Project Name: Johnson TownHomes

**Quinella Town Homes DR Staff Report Comments:**

Re: **Design Review Comments for the Johnson Townhomes**  
**Located at: 5165 N Quinella St. Garden City ID 83714**  
**Parcel No.: R7294240020**

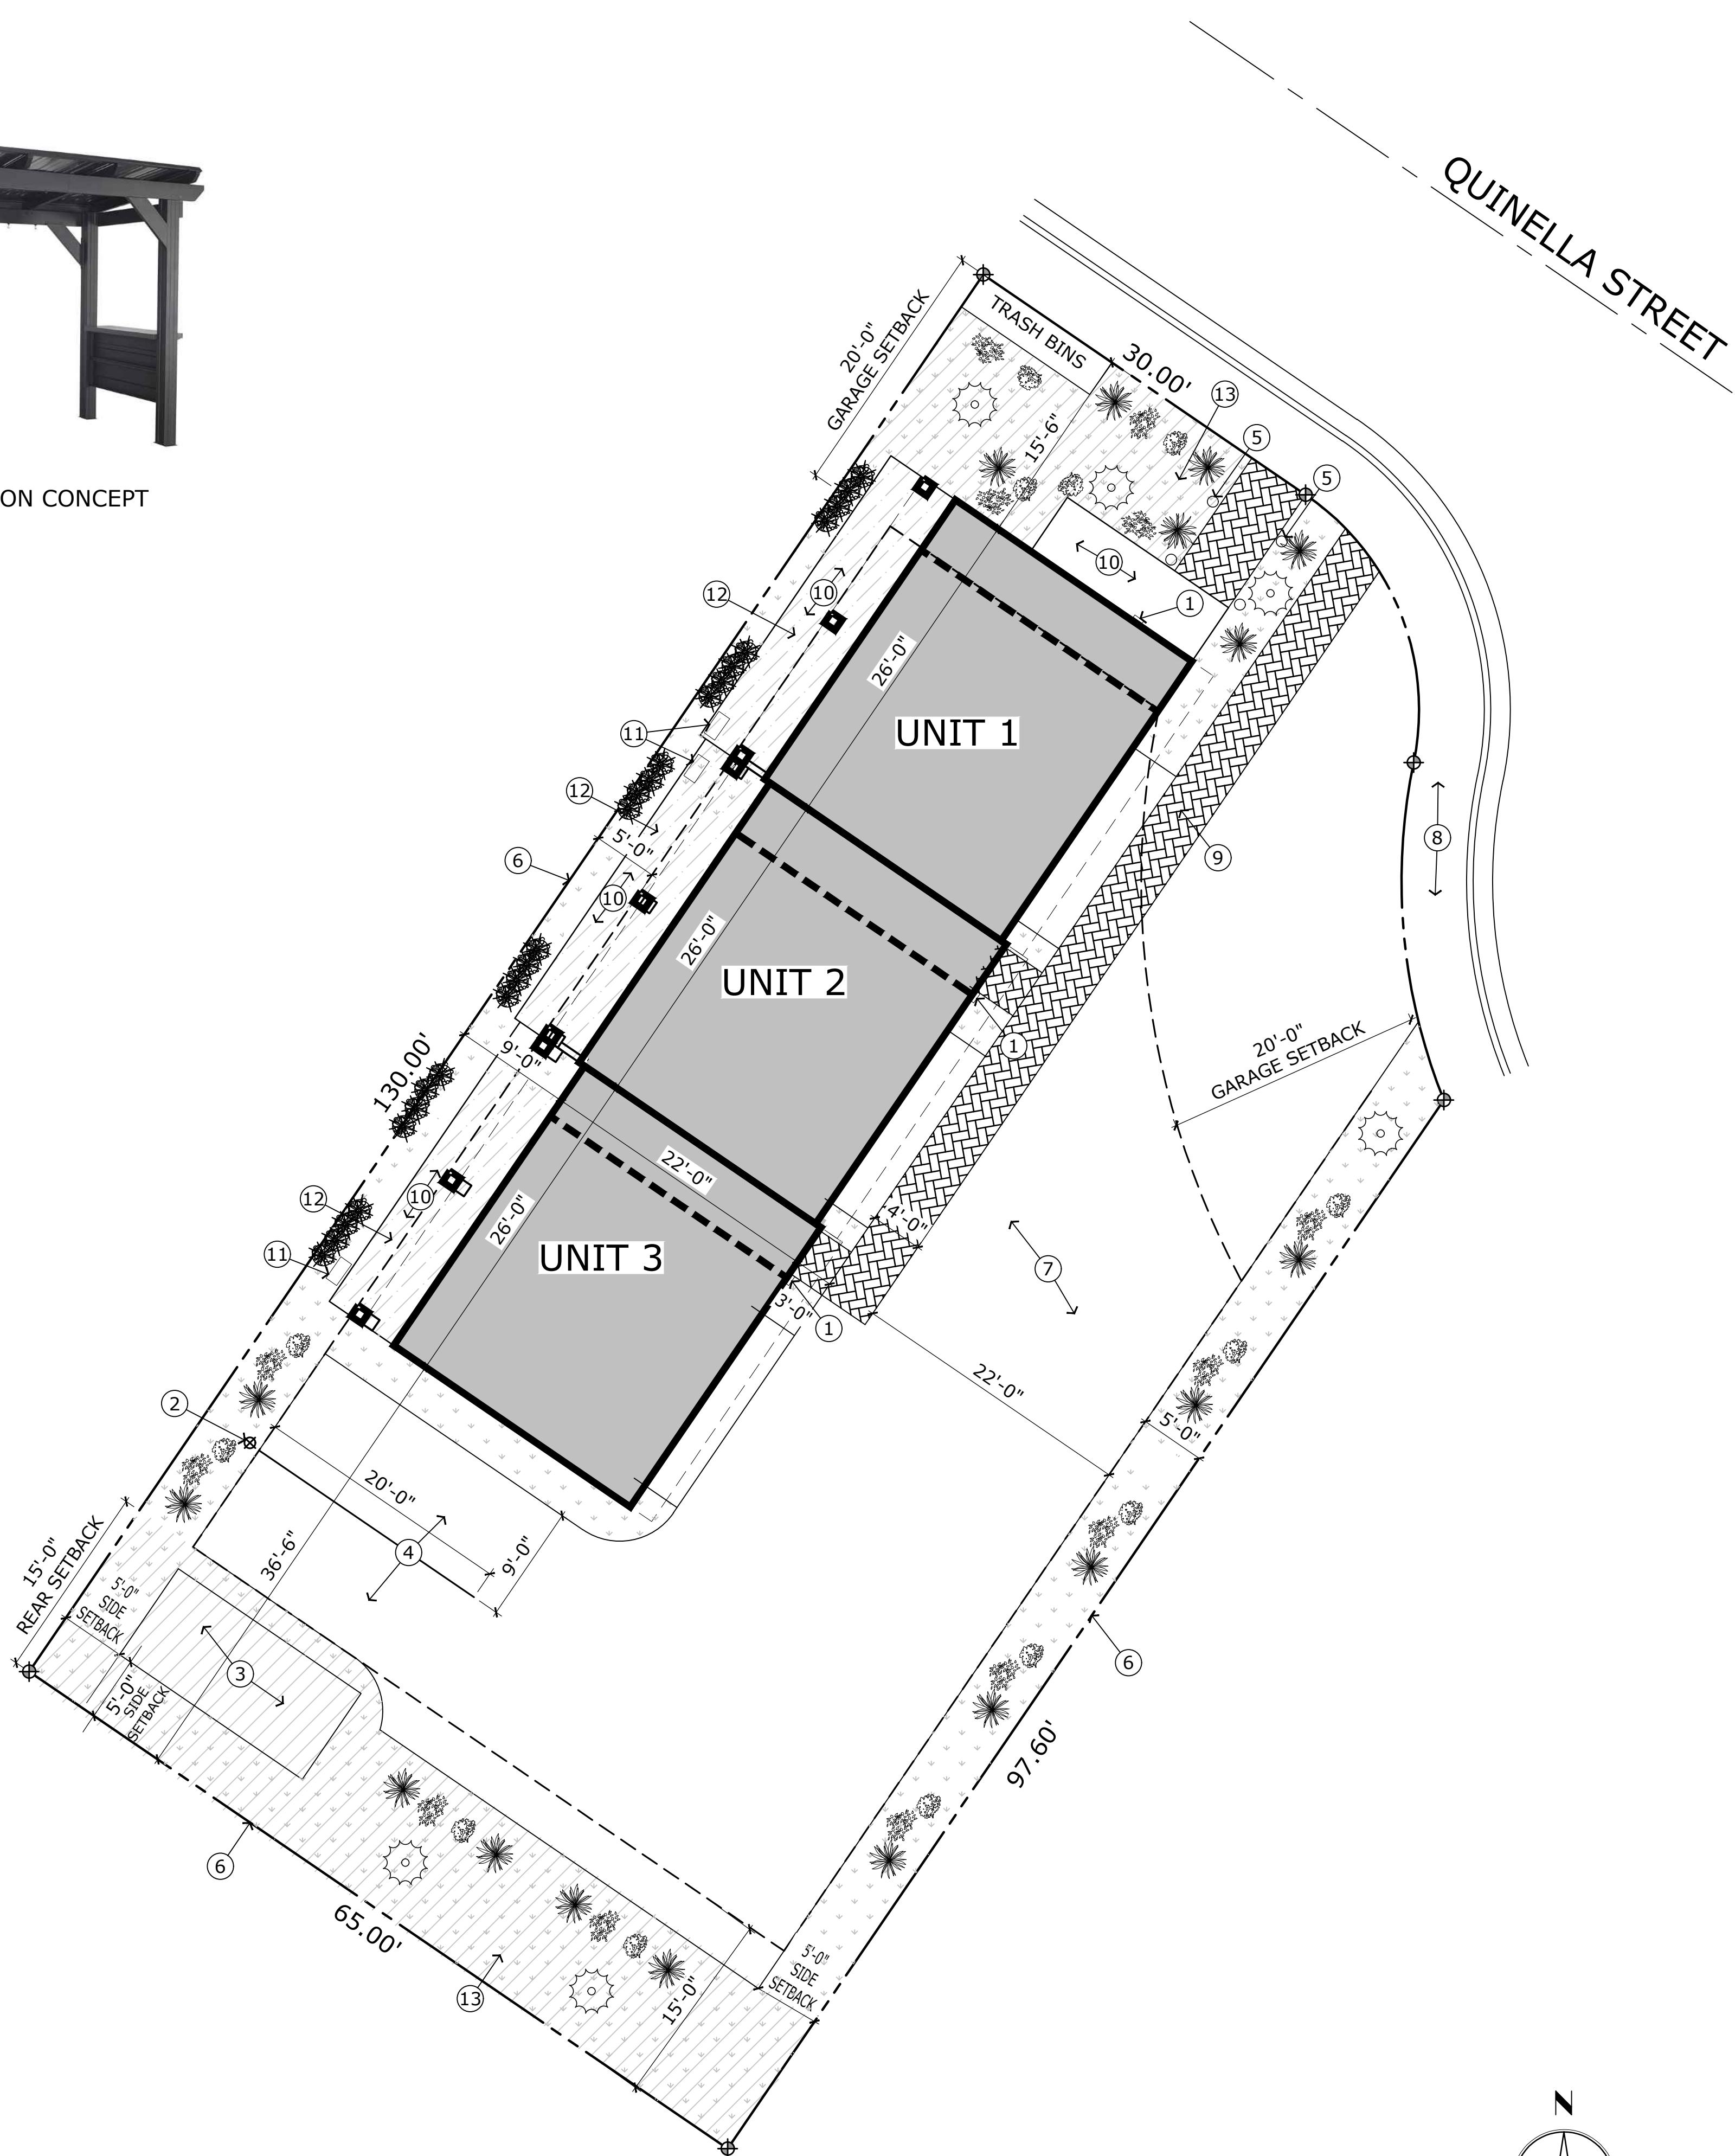
6. 8-4A-9 Waterways – There does not appear to be Boise River irrigation facilities on site.  
**6R.** Per email from Jason Jones, they no longer provide water to the property on Quinella. See PDF "Irrigation canal and ditch communication.pdf"

This property is outside of the area we currently service. While it's possible we serviced the property in the past, we no longer provide water to the property on Quinella. Let me know if you have any questions.  
Thanks  
Jason Jones

FLOOR PLANS  
SHEET NUMBER  
A-2.1

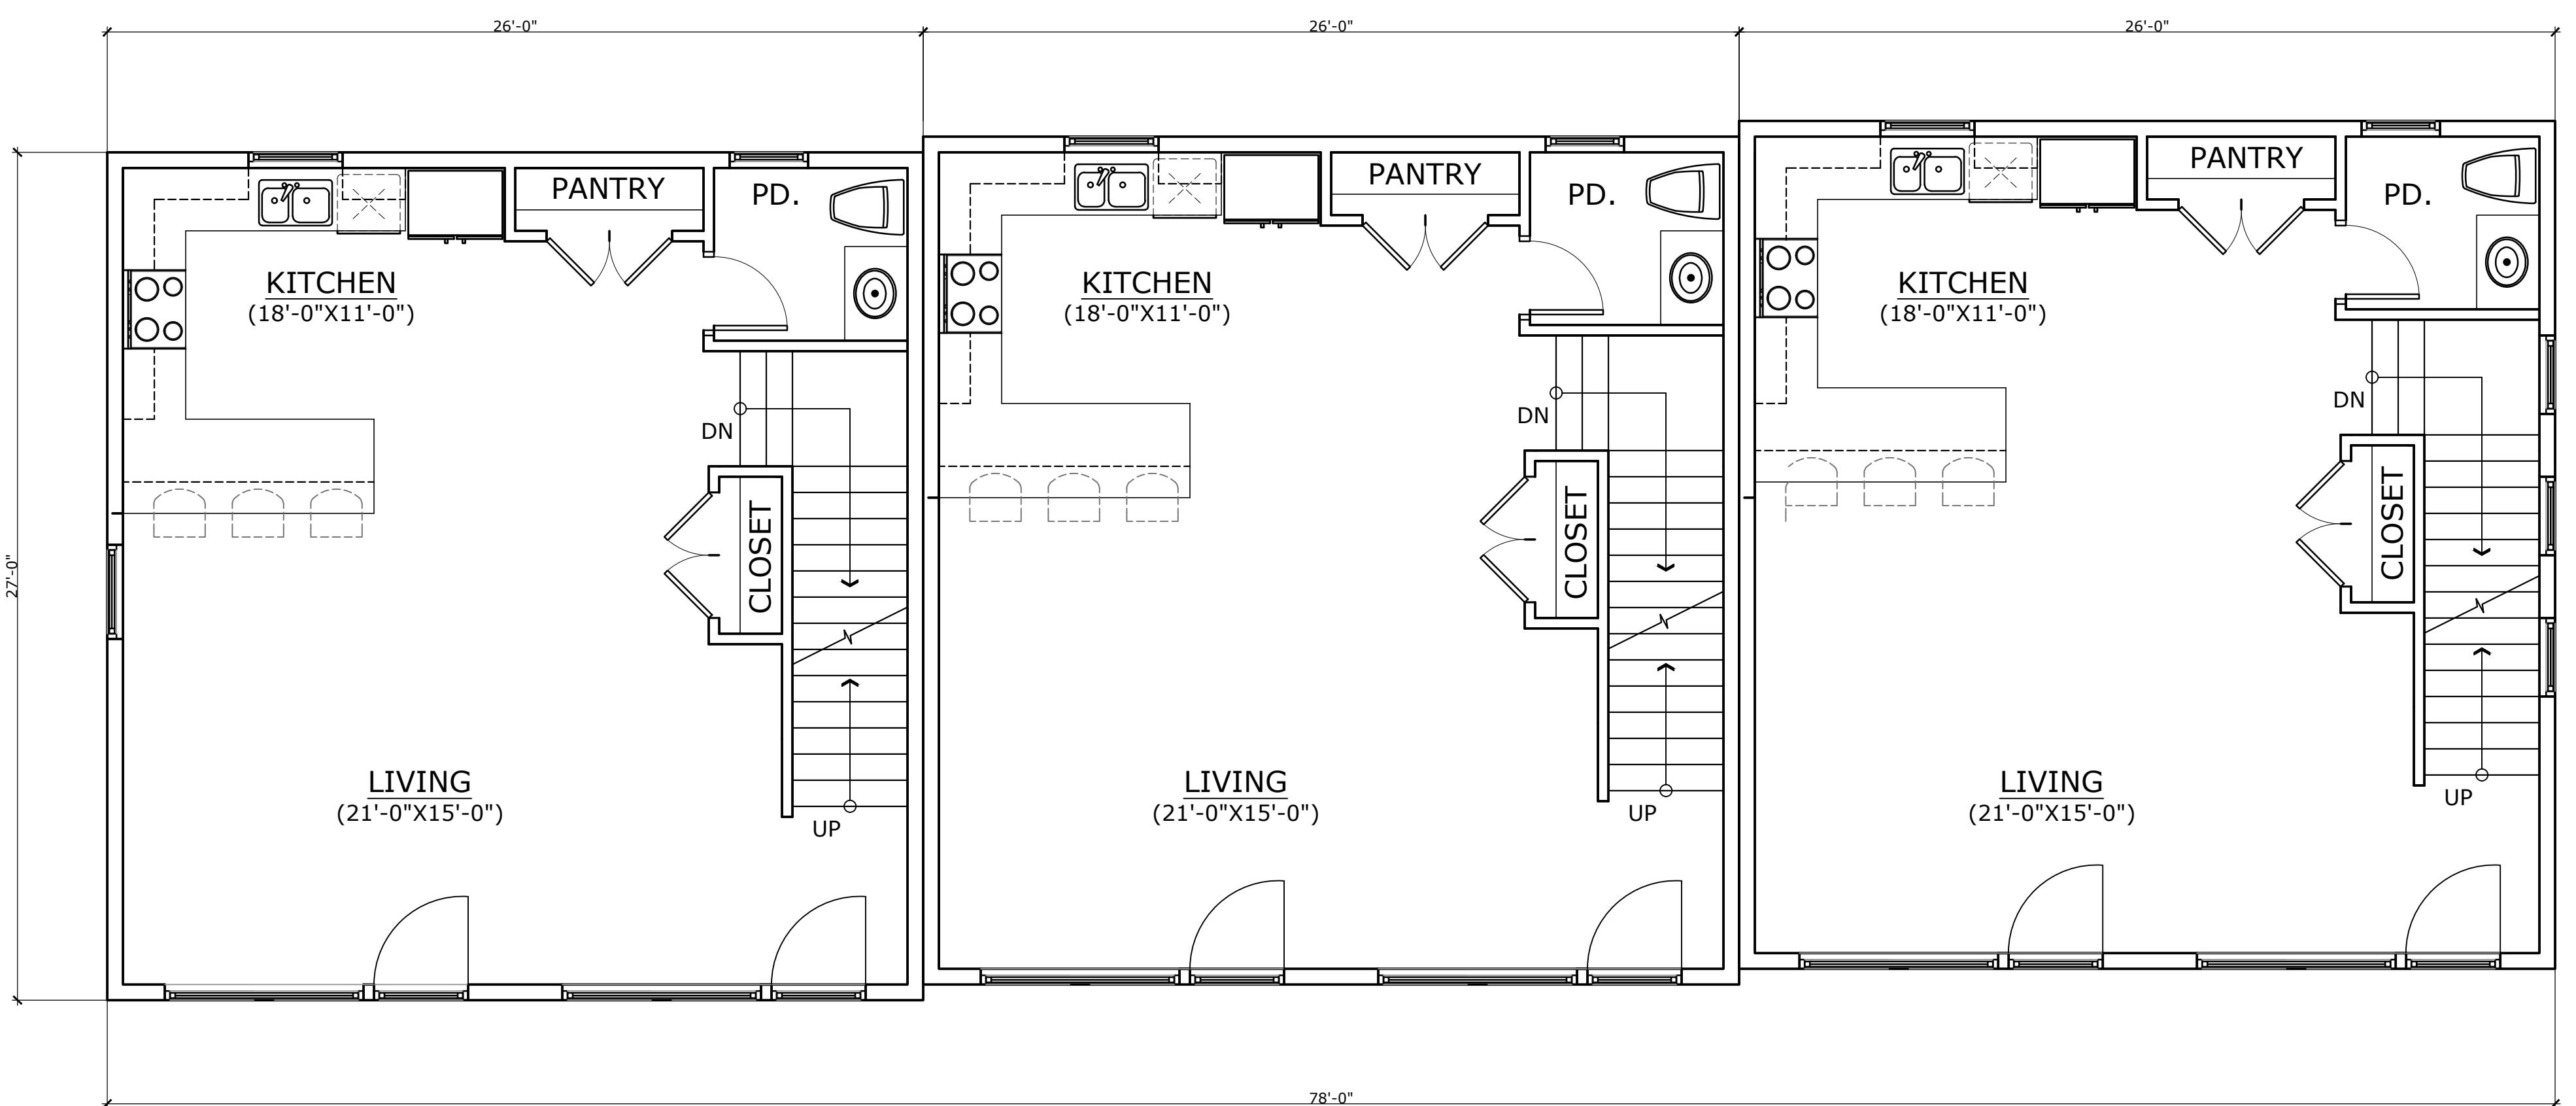
1. A-1.0 Site Plan - additional keynotes, dimensions, lighting, landscaping, and site calculations added.
2. A-2.0, A-2.1, A-2.2 Floor Plans - New windows added
3. A-3.0 Exterior Elevations - Facade elements added such as windows, awning, patio, and facade calculations
4. A-3.0 Exterior Elevations - facade elements changed such as paint, addressing, trim and dimensions.
5. DR Staff Report Response Comments - New page
6. \_\_\_\_\_
